SECTION 96(2) MODIFICATION: DA214/17 - CAMMERAYGAL HS SENIOR CAMPUS, 149 WEST STREET, CROWS NEST

This letter has been prepared to accompany a section 96(2) application lodged on behalf of the NSW Department of Education to modify Development Consent DA214/17. The DA approved the conversion of Crows Nest TAFE to a senior campus for Cammeraygal High School and the construction of a new multi-purpose hall.

Specifically, this application seeks to amend the design of the new multi-purpose hall. The proposal is the result of design development and community consultation. The modification will improve the amenity of adjacent residents and access to the facility.

Figure 2 – Proposed Illuminated School Signage

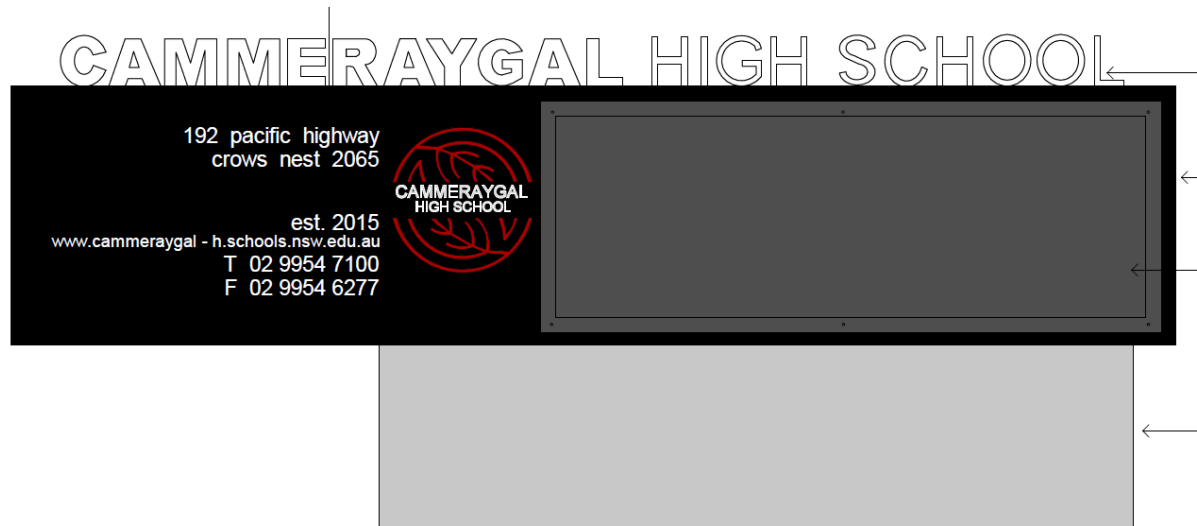
This section 96(2) seeks to delete *Condition C31: Illumination of Signage* to permit low-wattage illumination of a school notification signage board fronting West Street. The proposed illumination area will be approximately 0.7m wide by 2.0m high, thereby having a total area of 1.54m².

Figure 2 illustrates the proposed school signage and illumination area. The sign will be programmed to broadcast school events, holidays and achievements. The signage will not create undesirable light-spill or glare to residents and motorists along West Street.
